NLS2002093
December 19, 2002

Subject: Additional Information Related to License
Condition 2.C.(6) Seismic Evaluation
Cooper Nuclear Station
NRC Docket No. 50-298, DPR-46

**LEAKAGE PATHS FROM
OUTBOARD MSIV's
COOPER NUCLEAR STATION**

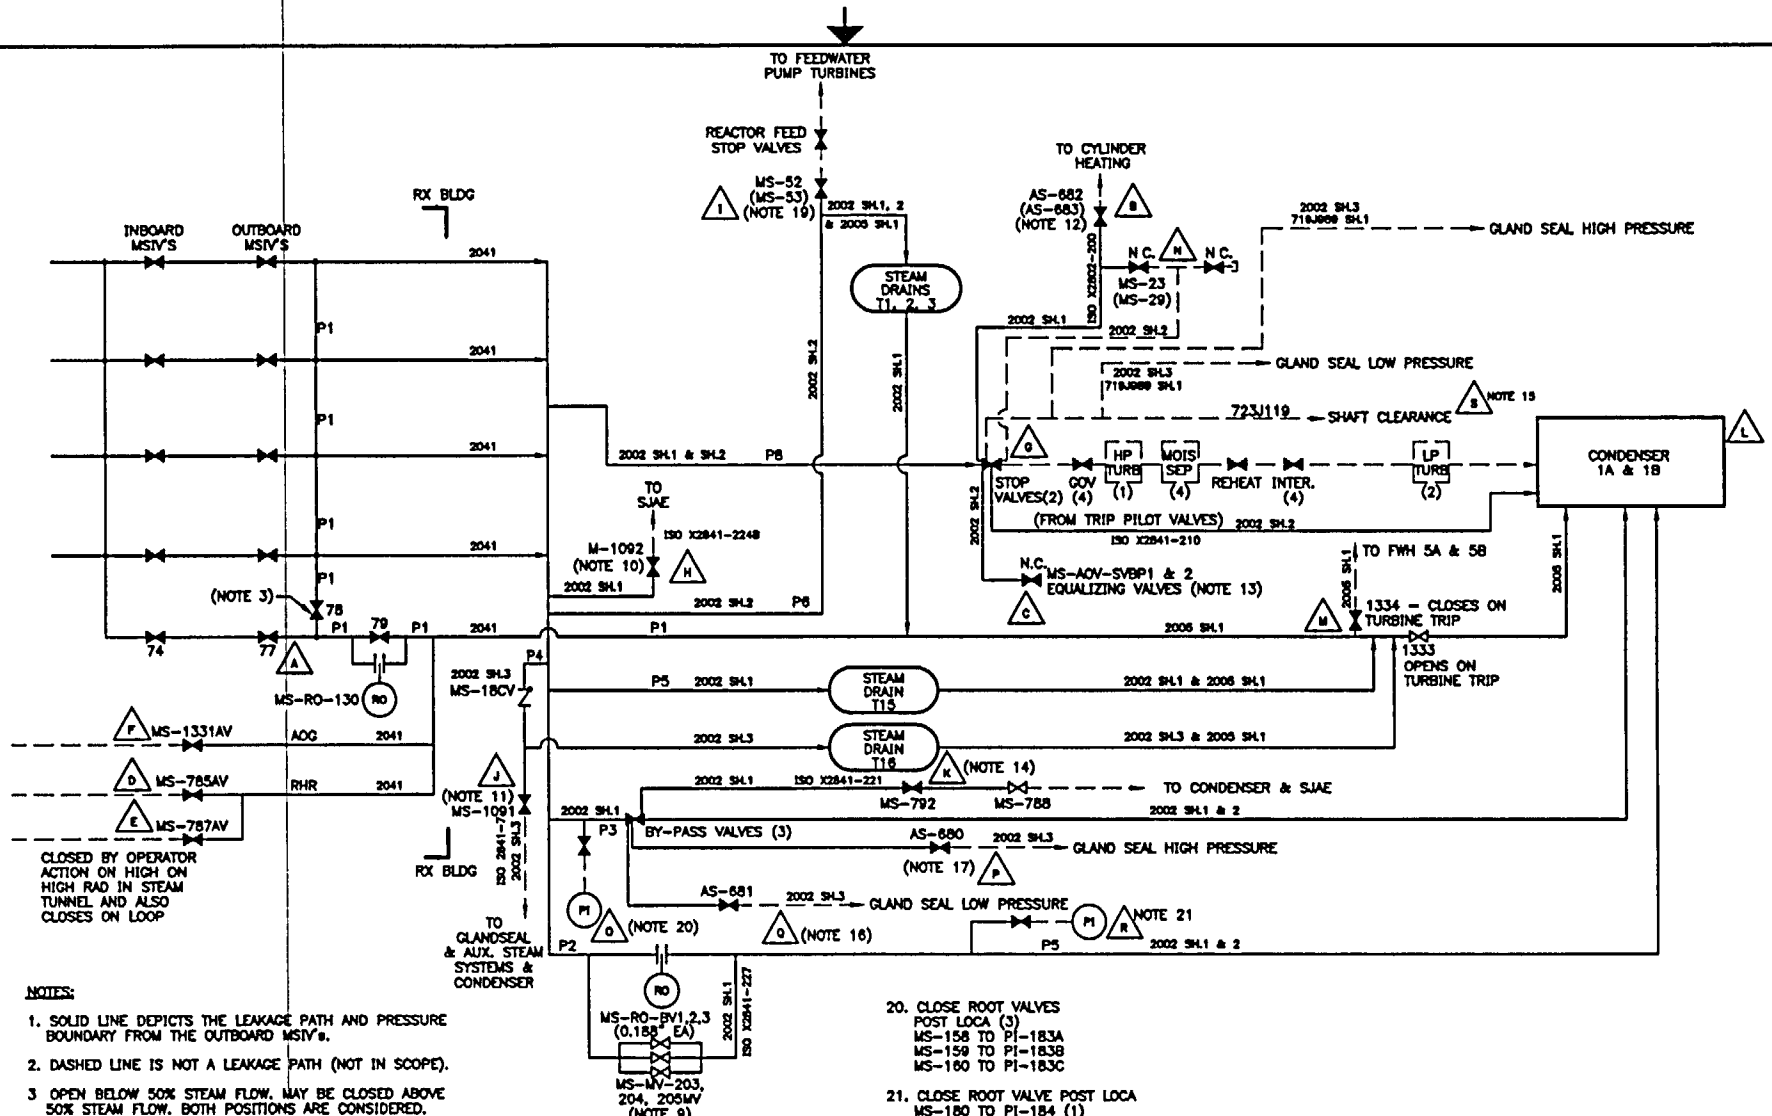
The final configuration of the MSIV leakage pathway is as shown on Enclosure 1. This drawing replaces the one provided in Enclosure 1 to Reference 1, and depicts the pathway piping and boundary valves (including those yet to be installed). Reference 1 described two options being pursued to direct the MSIV leakage to the Main Turbine Condenser. The principal underlying purpose for both of those options was to provide assurance that leakage outside of the MSIV leakage pathway boundary via the Turbine Stop Valve shaft leakage area would be minimized, as discussed in Appendix C to NEDC-31858P Revision 2, "BWROG Report for Increasing MSIV Leakage Rate Limits and Elimination of Leakage Control Systems." After due consideration, the Nebraska Public Power District (NPPD) has decided on a better course of action. The cross-sectional leakage area is being reduced by mechanically adjusting the Stop Valve actuator/control shaft positions through use of a special pre-staged tool, applied as a post-Loss of Coolant Accident manual action.
